Access Compliance Report

Public Rights-of-Way

Intersection ID: 17457	Main Street: S_WENDOVER_RD	Cross Street: VERNON_DR	Location: W
ADA ID: 8A35864B82A5	Ramp Type: Perp	Initial Pass/Fail: Fail	Overall Compliance: No
		Severity Score: 37.5

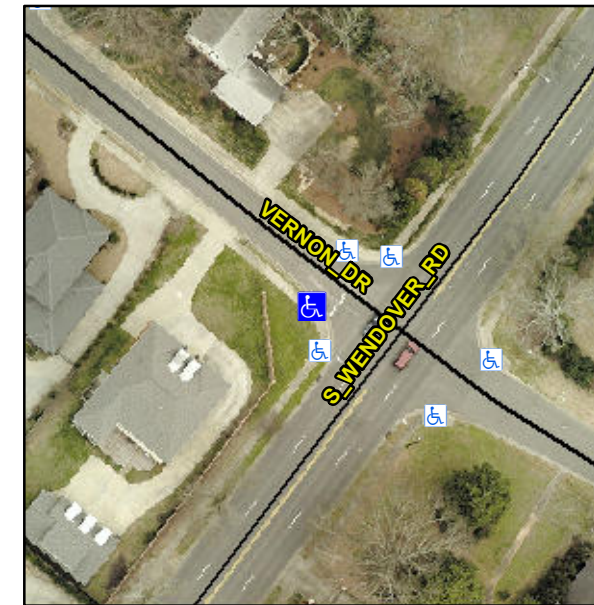
R304.2.2, R304.5.3

Compliance	Description	Data	Compliance	Description	Data
N/A	Ramp Length (in)	87.0	No	Ramp Slope (%)	10.1
Yes	Ramp Width (in)	48.0	No	Ramp XSlope (%)	7.6
N/A	Flare Type LT	N/A	N/A	Flare Type RT	N/A
N/A	Flare Slope LT (%)	N/A	N/A	Flare Slope RT (%)	N/A
N/A	Flare Traversable LT?	N/A	N/A	Flare Traversable RT?	N/A
N/A	Landing Length (in)	N/A	N/A	DWS Provided?	N/A
N/A	Landing Width (in)	N/A	N/A	DWS Contrast?	N/A
N/A	Landing Slope (%)	N/A	N/A	DWS Length (in)	N/A
N/A	Landing X Slope (%)	N/A	N/A	DWS Full Width?	N/A
N/A	Landing Curb? (Y/N)	N/A	N/A	DWS Offset (in)	N/A
N/A	Shared Landing?	N/A			
N/A	Gutter Ponding?	N/A	N/A	Gutter Slope (%)	N/A
N/A	Gutter Lip Ht (in)	N/A	N/A	Gutter X Slope (%)	N/A
N/A	Painted X Walk1?	No	N/A	Painted X Walk2?	N/A
	X Walk 1 Direction	To NE		X Walk 2 Direction	N/A
N/A	X Walk 1 Width (in)	N/A	N/A	X Walk 2 Width (in)	N/A
	X Walk 1 Slope (%)	1.1		X Walk 2 Slope (%)	N/A
	X Walk 1 X Slope (%)	3.9		X Walk 2 X Slope (%)	N/A

Remove & Replace Entire Ramp.
